1-5. RIGHTS OF GROUNDWATER USERS

Query response to the following SEARs for SSD 5765:

Figure 1: Location of monitoring wells (Jacobs (Australia), 2020)

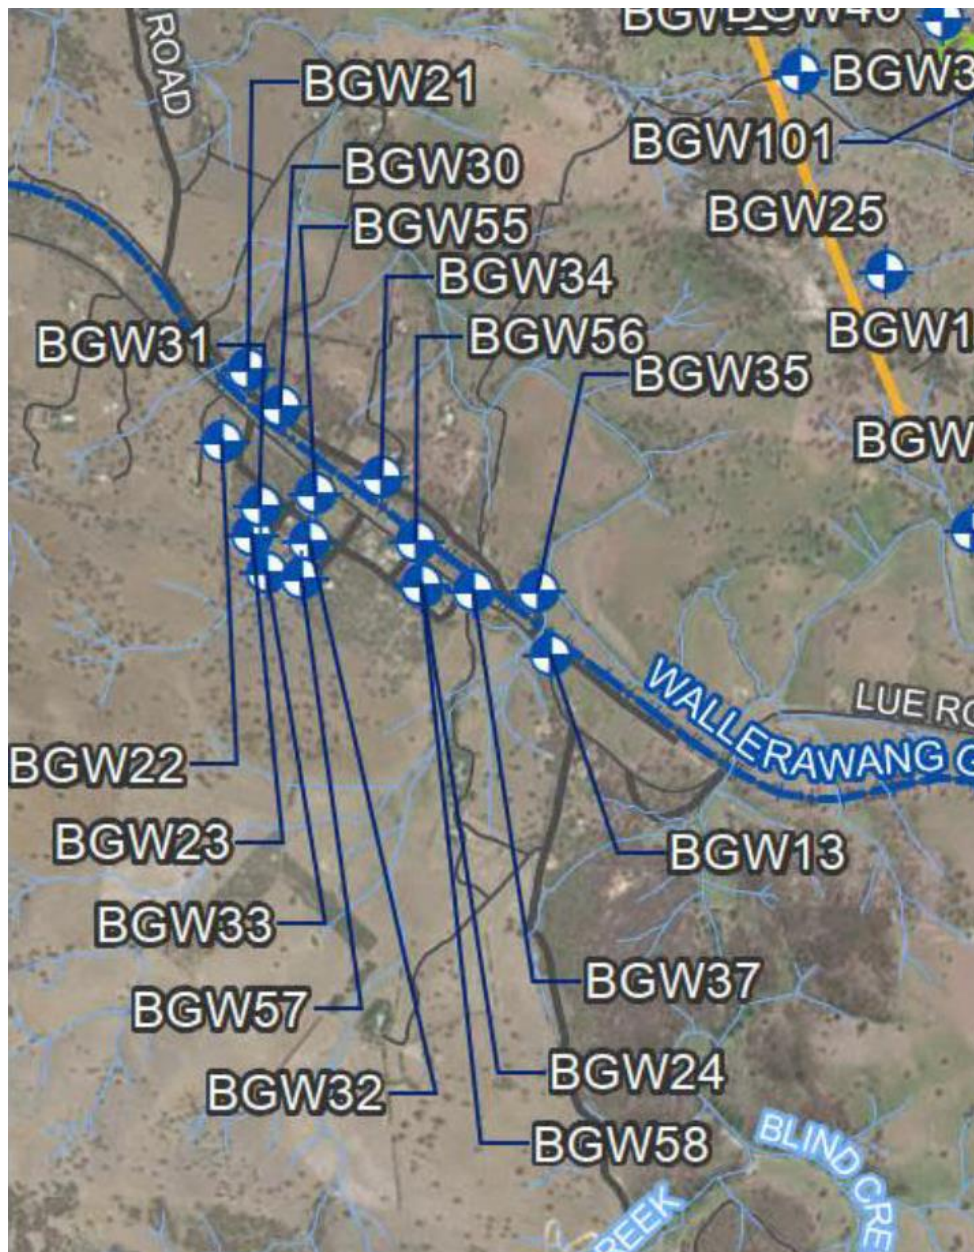
The monitoring bores reported in the EIS located within 1.5 km of Lue are shown in Table 1. The *NSW Aquifer Interference Policy 2012* requires baseline groundwater conditions to be established. It also requires quality impacts from licensed water users of connected groundwater to be established.

Despite conclusions portrayed in Table 22 (Jacobs (Australia), 2020, pp. 5-110), there is no evidence of non-potable water quality in bores in Lue from the sampling undertaken (Table 1).
